WYOMING ESTATES SUBDIVISION

FINAL DRAINAGE REPORT

FEBRUARY 19, 2018

Project Number 03433

CULVERT DESIGN FORM

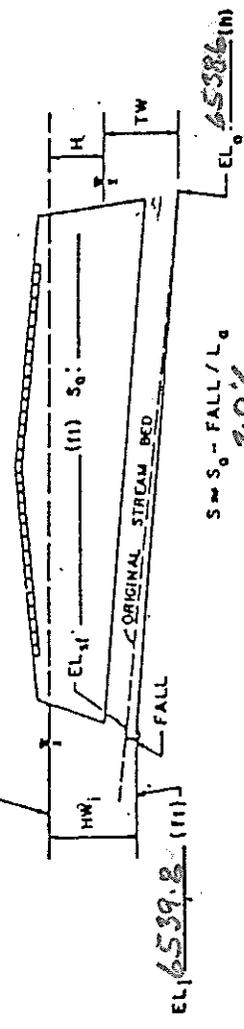
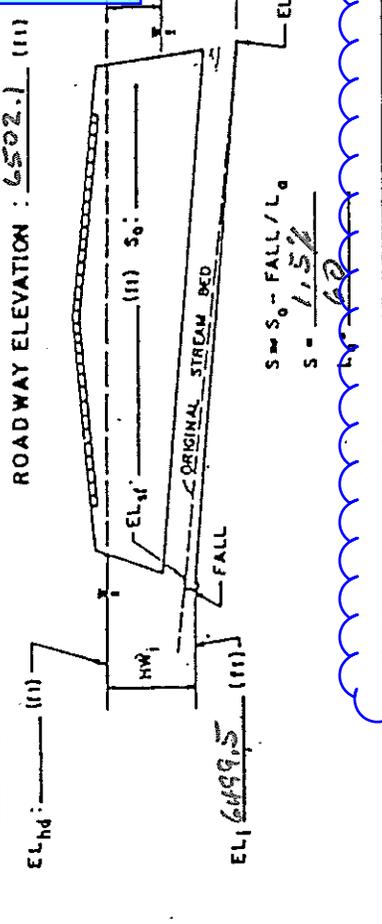
Please provide complete calculations. Additionally provide calculations showing you meet overtopping criteria per DCM Vol. 1 table 6-1

DRAINAGE PLAN
 EXISTING CONDITIONS

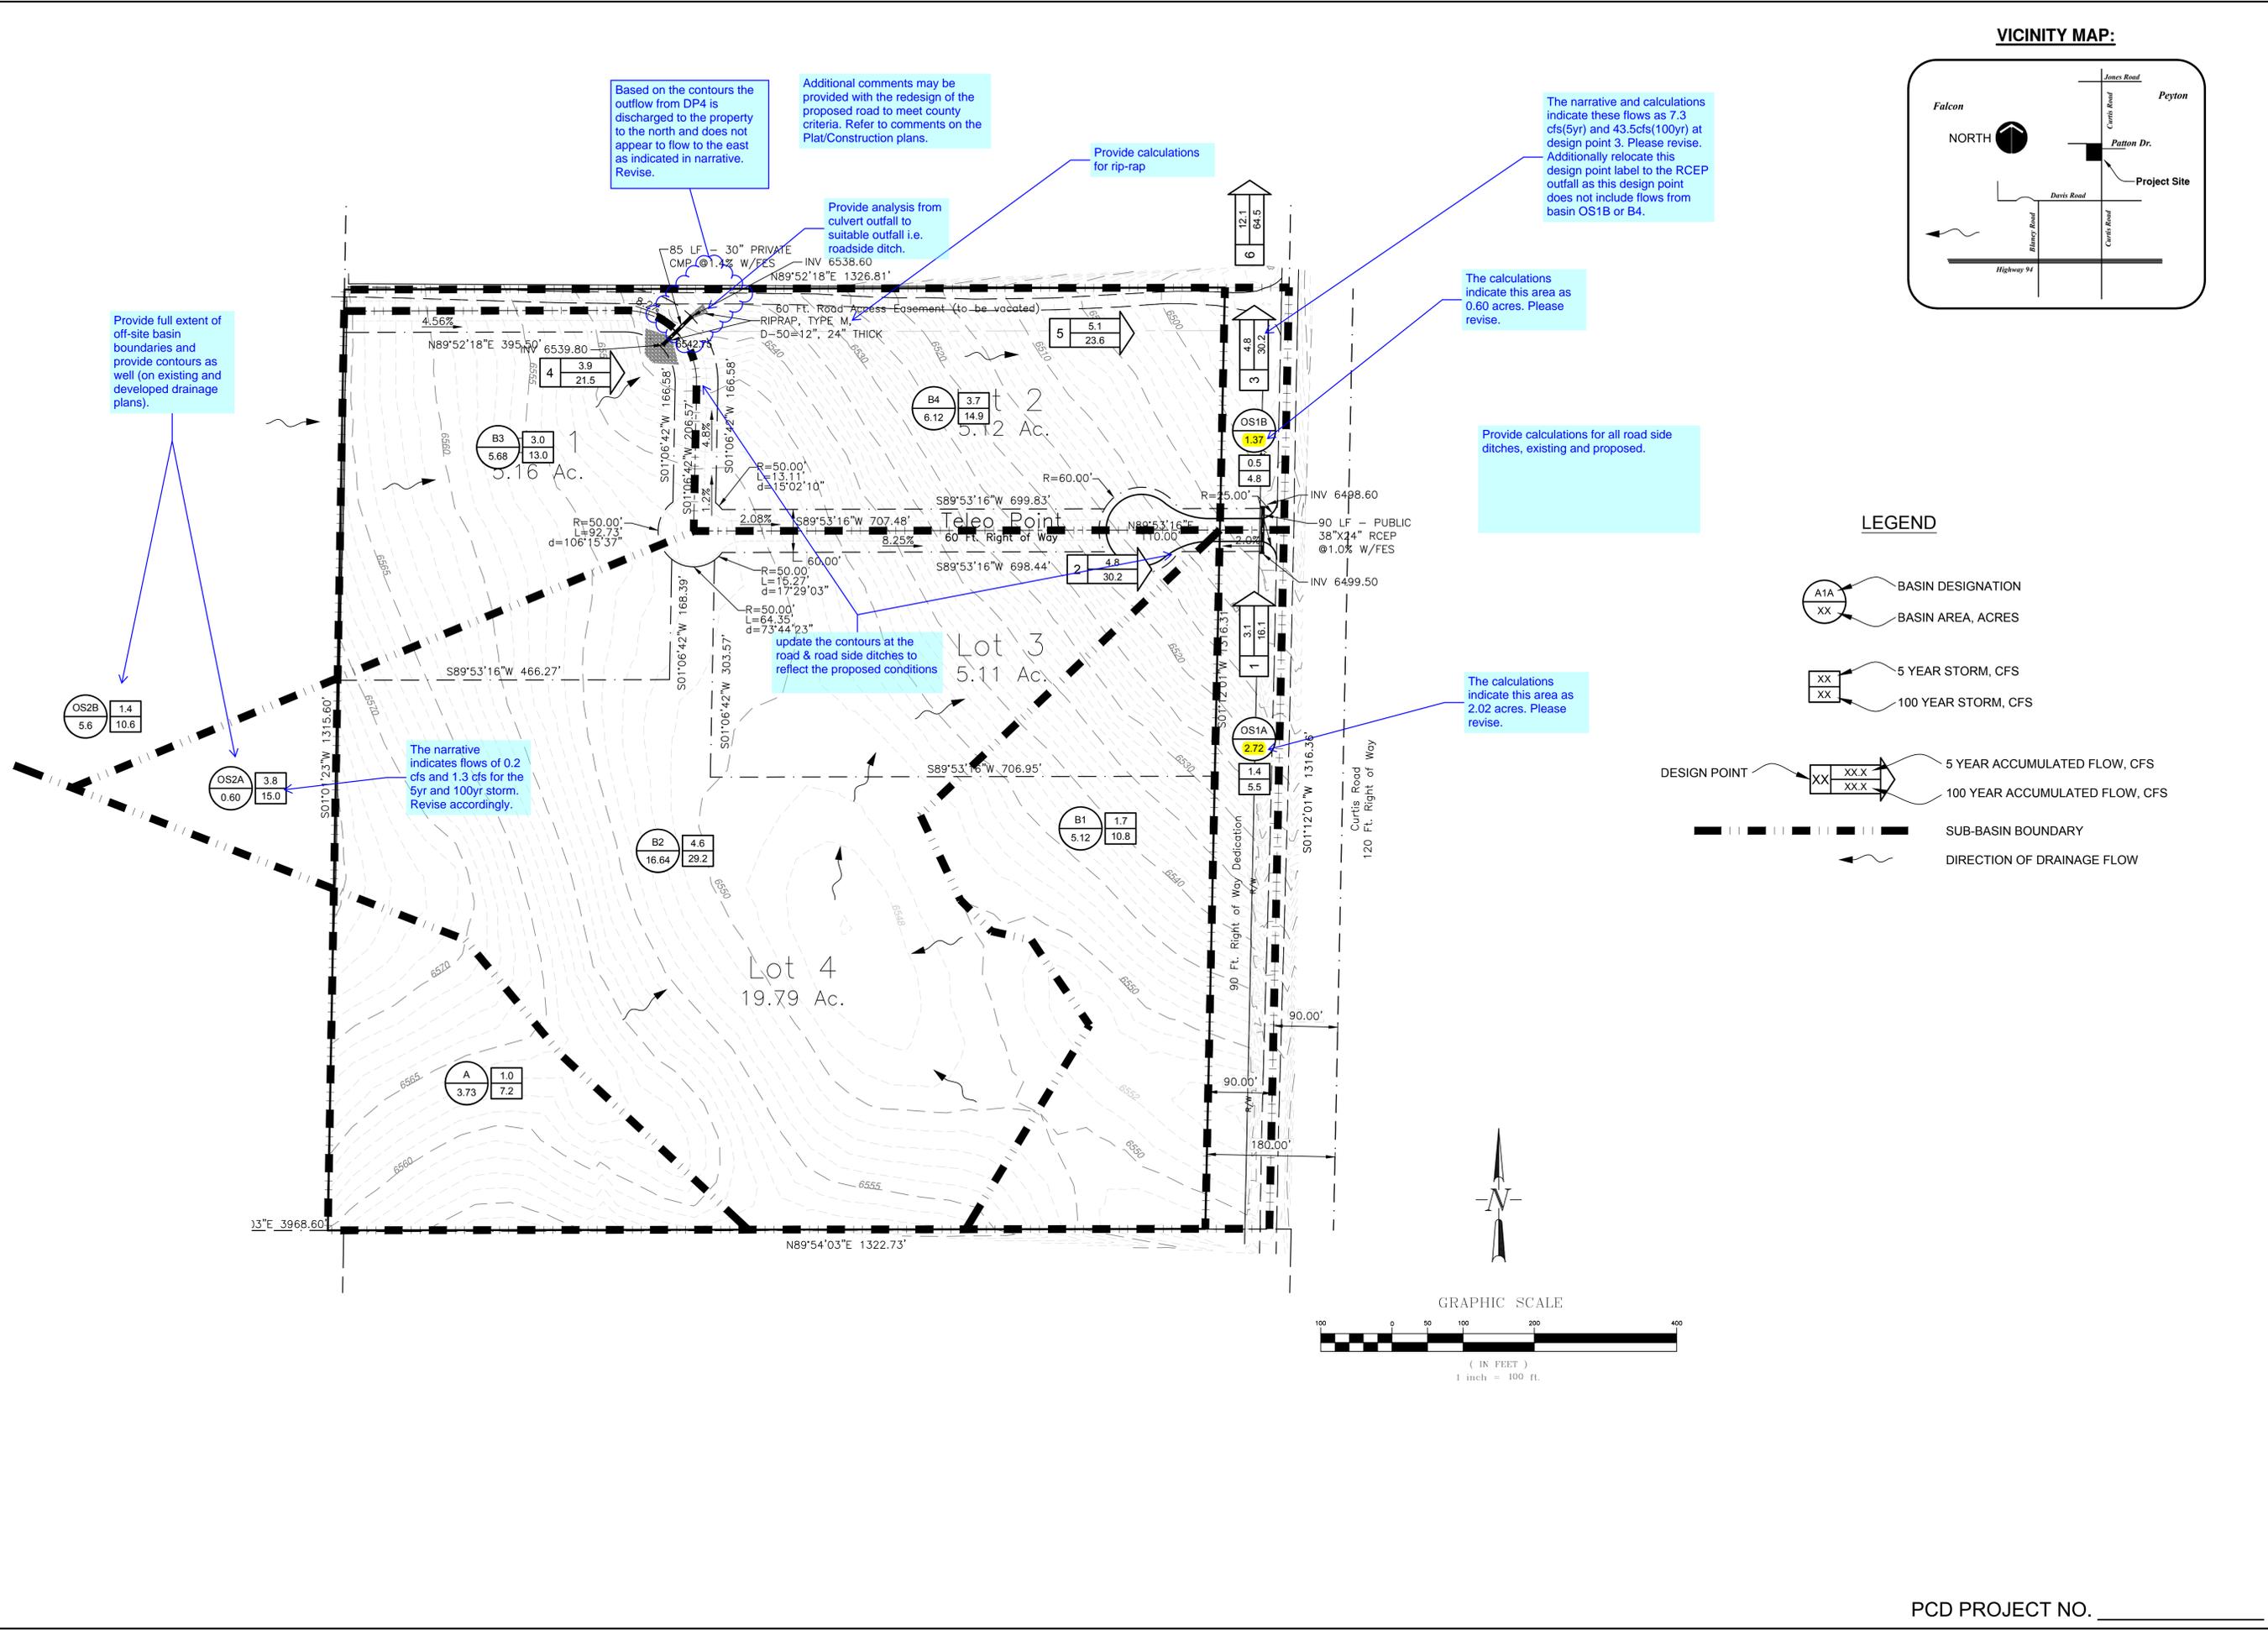
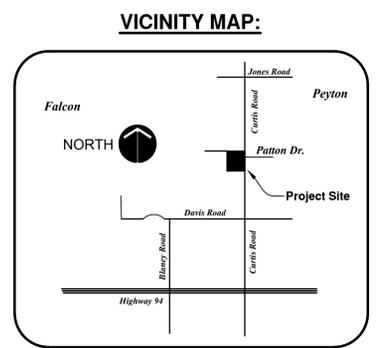
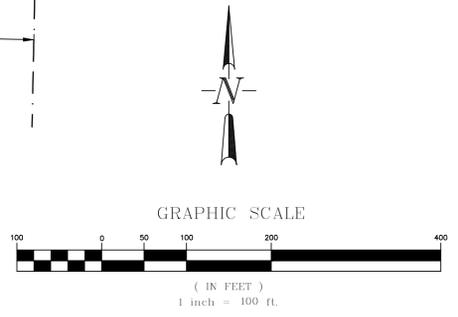
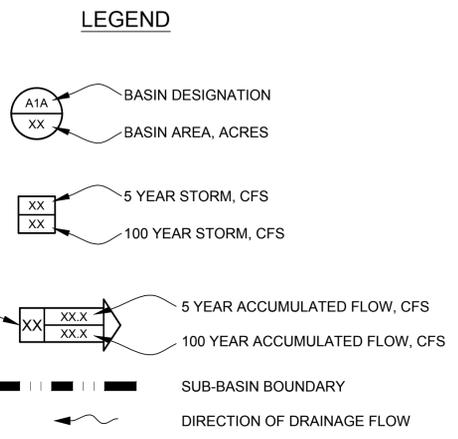
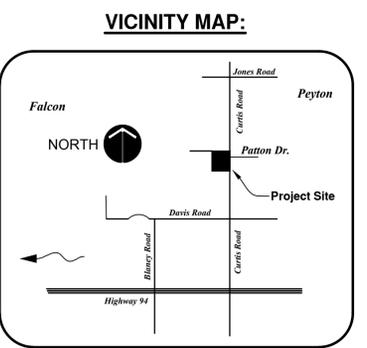
Revise label so that it matches the narrative and calculations.

Please show flow arrows on drainage plan
